Range Rover Sardinia Cup

Equipment Substitution Request

Request No: 06

Boat: Sardinia Cup - SC 1 - GBR 51X - Django wr - Ettore Botticini

[c85790fb-74b2-4e79-993e-99e37c737d09.jpeg](#) 710 KB

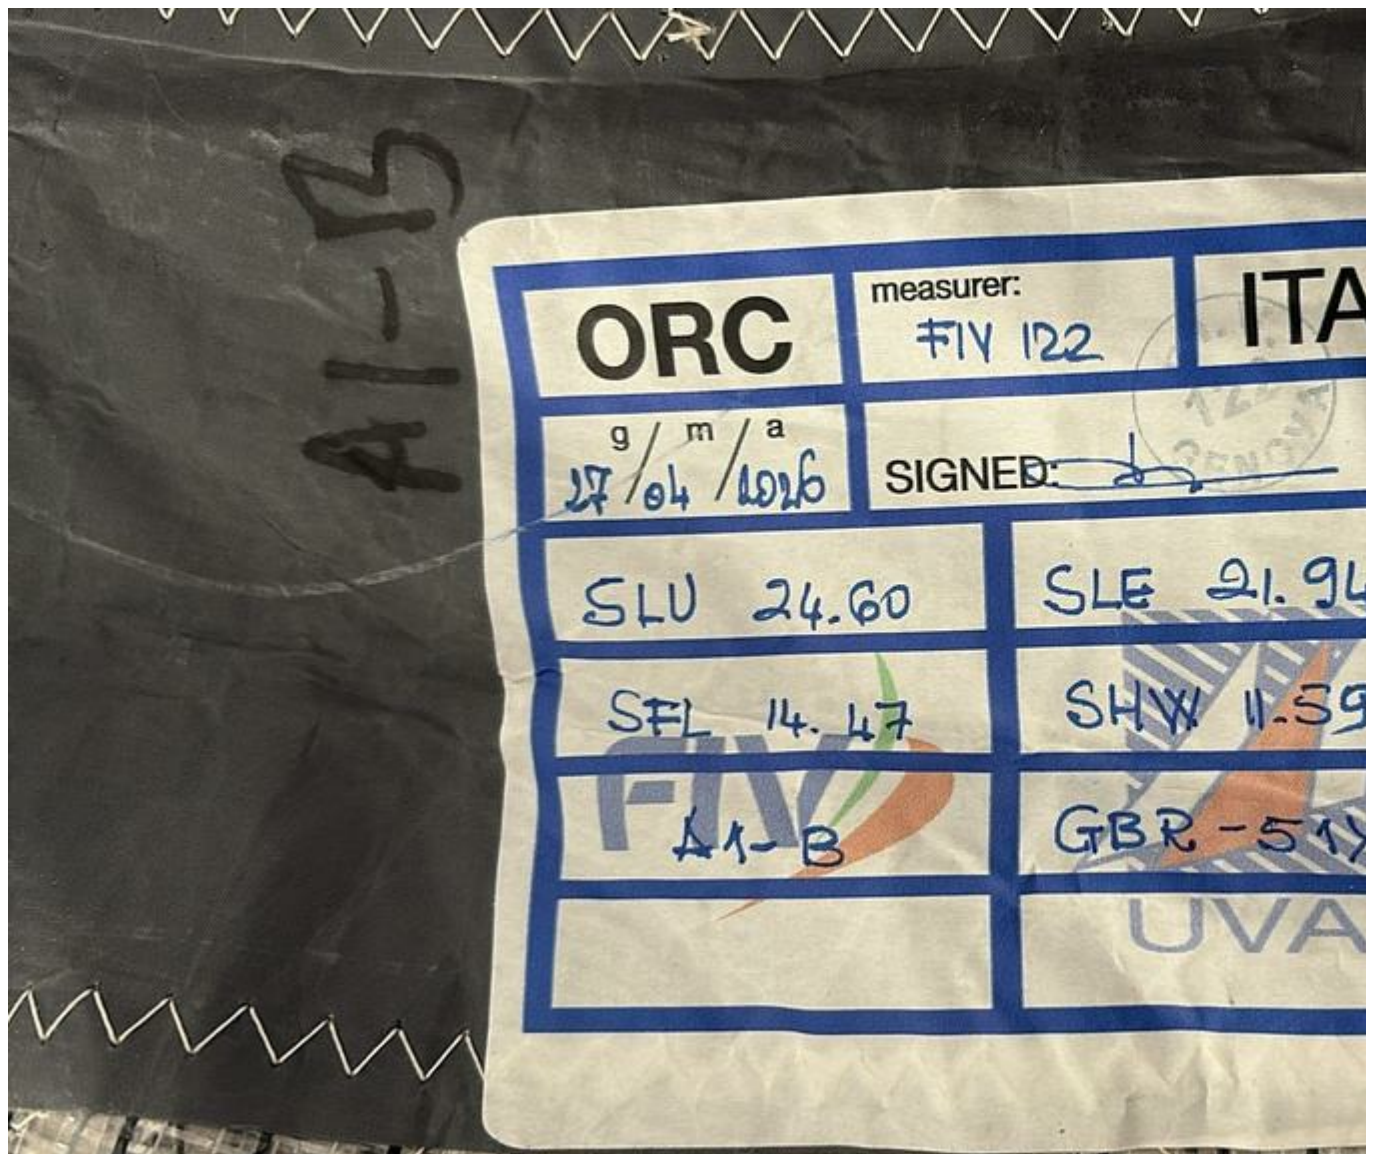
As per previous communication we are requesting to replace our A3-1 with our A1-B in our sail inventory.

Attached you can find the A1-B stamp which shows that the new kite is compliant with our current certificate.

Response: Not Approved

Any replacement of a sail should only be with one of the same code and SFL:SMW ratio and similar size.
